Program Manager  
Office of Renewable Energy  
Bureau of Ocean Energy Management  
45600 Woodland Road  
Sterling, Virginia 20166

**RE: Public Comments on Empire Wind Draft Environmental Impact Statement (DEIS)  
Docket BOEM-2022-0053**

**Figure 3.9-19 Sea Scallop Revenue Intensity in Relation to the Project Area**

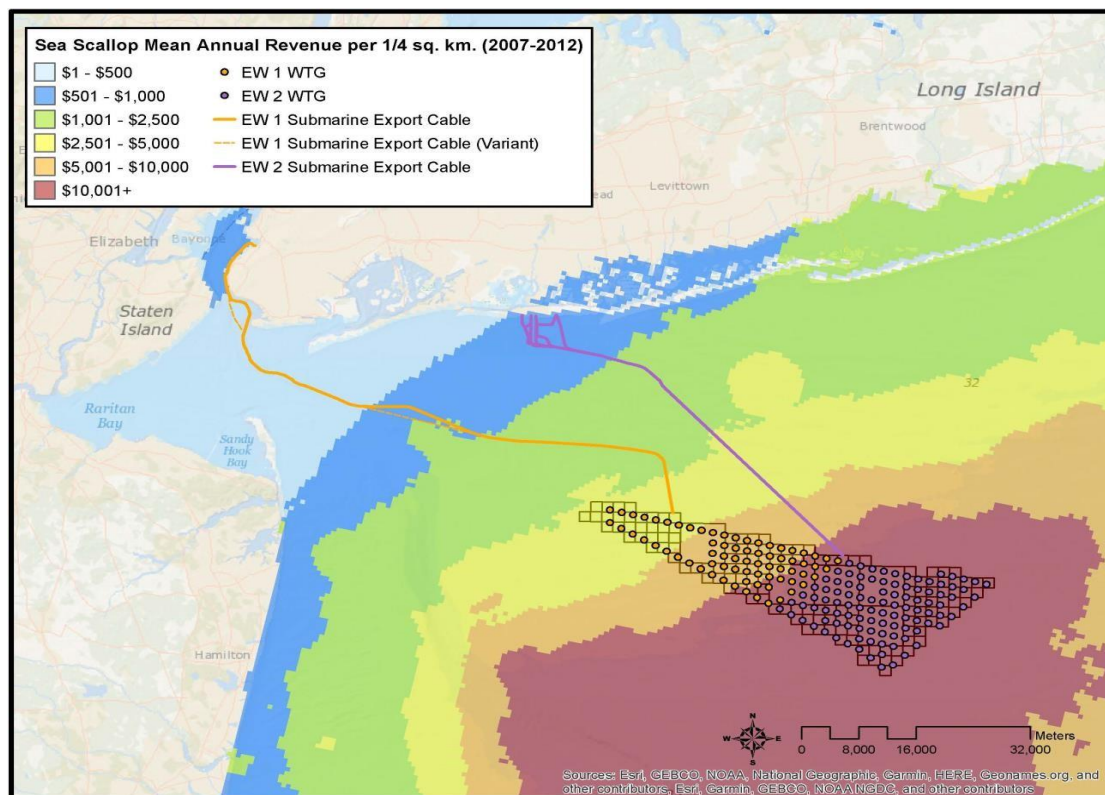
and for-hire recreational fishing in the geographic analysis area would be major. The Proposed Action would contribute to the cumulative impact rating primarily through permanent impacts associated with the presence of structures, including navigational hazards, gear loss and damage, and space-use conflicts. The cumulative impacts on commercial fisheries and for-hire recreational fishing would be major because the fishing industry would experience unavoidable disruptions beyond what is normally acceptable". (3.9-73). The map below shows Empire Wind 2 sits squarely over the leading catch area for scallops, the second most valuable seafood.

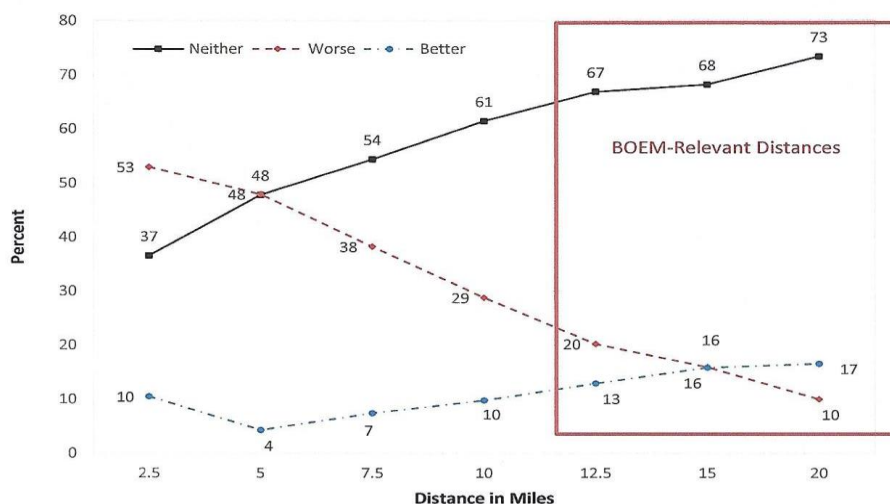
The Ocean wind DEIS quotes a University of Delaware study<sup>8</sup>, “evaluating the impacts of visible offshore turbines on beach use found that turbines visible more than 15 miles from the viewer would have negligible impacts on businesses dependent on recreation and tourism activity (Parsons and Firestone 2018). Below is a copy of the chart quoted from the UD study.

However, even with the studies problems it has some use. The figure shows at 10 miles 29% found the view worse while only 10% found it better for a 19% difference choosing worse. At 7 miles 38% found the view worse compared to 7% favorable, a 31% difference. So ignoring the taller towers in the Empire Wind 1 project we see perhaps 25% of tourists will find the cumulative impact worse. The impact of taller towers can be approximated by assuming the towers are 1.64 times closer (the ratio of 579’ tall towers to 951’ tall towers). The proposed Empire Wind project would be equivalent to about 10 miles off the coast. The proposed project then should be considered to have a major impact on tourism.
